REDLINE REVISION 1 /06

GREENLINE REVISION 2 5/15/07

TS 5 OF 10

MARYLAND DOT - STATE HIGHWAY ADMINISTRATION
Office of Traffic & Safety
TRAFFIC ENGINEERING DESIGN DIVISION
TRAFFIC SIGNAL PLAN
MD 26 (LIBERTY RD.) AND ESSEX ROAD

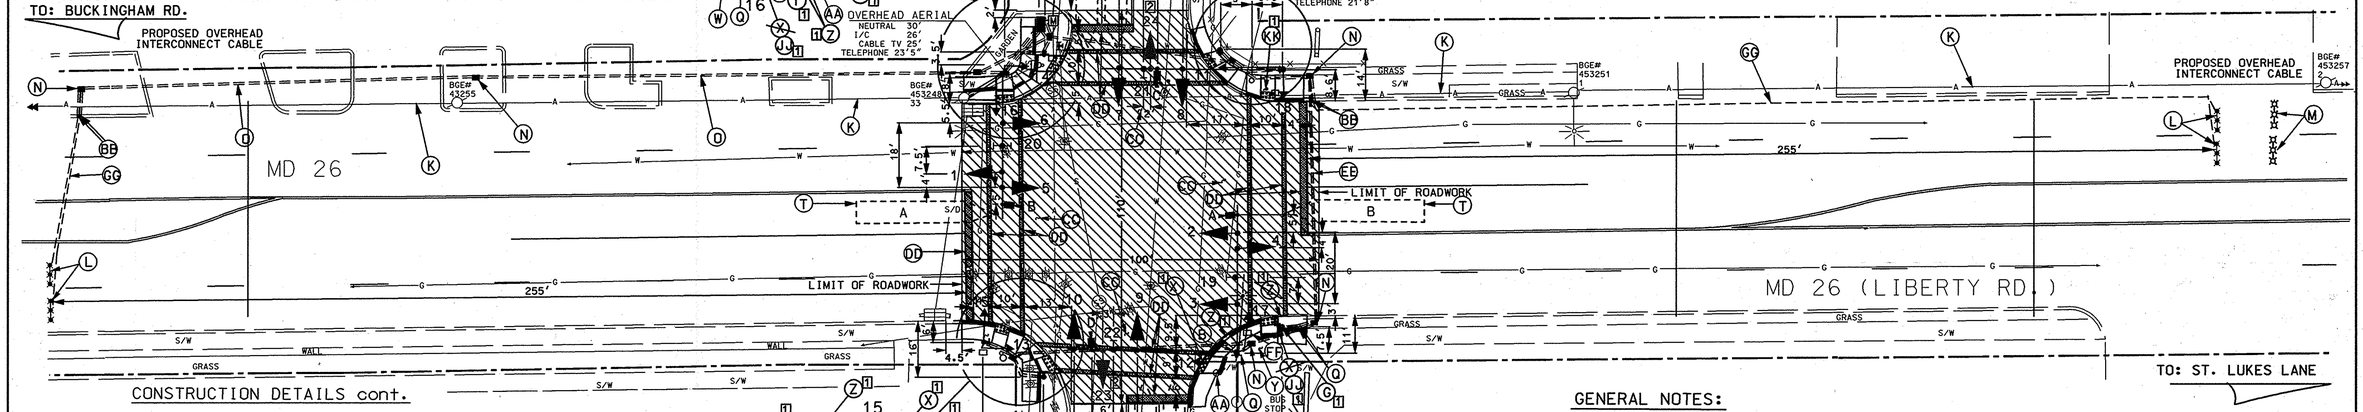
2 3, 6, ~~7~~, 8, ~~9~~, 10 — 12"

RELOCATED DUE TO THE RAMP
1 E. INSTALL 10' PEDESTAL POLE WITH BREAKAWAY BASE (CUT TO 6'). NAVIGATION AUDIBLE PEDESTRIAN PUSHBUTTON AND SIGN NO. 26.(NOTE: 1-3" 90° PVC BEND).

RELOCATED DUE TO THE ROAD
1 G. INSTALL 10' PEDESTAL POLE WITH BREAKAWAY BASE. (CUT TO 6'). NAVIGATOR AUDIBLE PEDESTRIAN PUSH BUTTON WITH SIGN NO. 28. (NOTE: 1-3" 90° PVC BEND).

RELOCATED DUE TO THE ROAD
1 H. INSTALL 10' PEDESTAL POLE WITH BREAKAWAY BASE. (CUT TO 6'). NAVIGATOR AUDIBLE PEDESTRIAN PUSH BUTTON WITH SIGN NO. 29. (NOTE: 1-3" 90° PVC BEND).

1 R. INSTALL 2" SCHEDULE 80 PVC CONDUIT - TRENCHED ~~FOR PHONE DROP.~~

CHANGE
1 S. INSTALL METERED SERVICE PEDESTAL WITH 4" TRENCHED TO BASE OF BGE POLE #44009, PROVIDE 1' STUB AND PULL STRING FOR INSTALLATION OF SERVICE FEED.(NOTE: 1-4"&2-2" 90° PVC BENDS).

1 U. ~~OVERHEAD~~ SERVICE INSTALLED BY BGE. UNDERGROUND

1 V. USE BGE POLE NO. 273599 ~~FOR OVERHEAD SERVICE FEED~~ AND UNDERGROUND PHONE DROP TO SIGNAL POLE.

1 X. EXCAVATE AND INSTALL PEDESTRIAN TYPE ~~'A'~~ 655.12 RAMP WITH 2' OF BRICK PAVERS AT THE ROAD EDGE.

1 Y. EXCAVATE EXISTING AND INSTALL PROPOSED 5" SIDEWALK.

1 Z. REMOVE EXISTING CURB AND GUTTER AND INSTALL STANDARD TYPE 'A' ~~(DEPRESSED).~~ 8" CURB AND 12' GUTTER PAN.

1 JJ. EXCAVATE AND INSTALL PEDESTRIAN RAMP TYPE 655.13 WITH 2' OF BRICK PAVERS AT THE ROAD EDGE.

1 KK. RELOCATE EXISTING BUS SIGN AND NEWS BOXES OUT OF PROPOSED RAMP AREA.
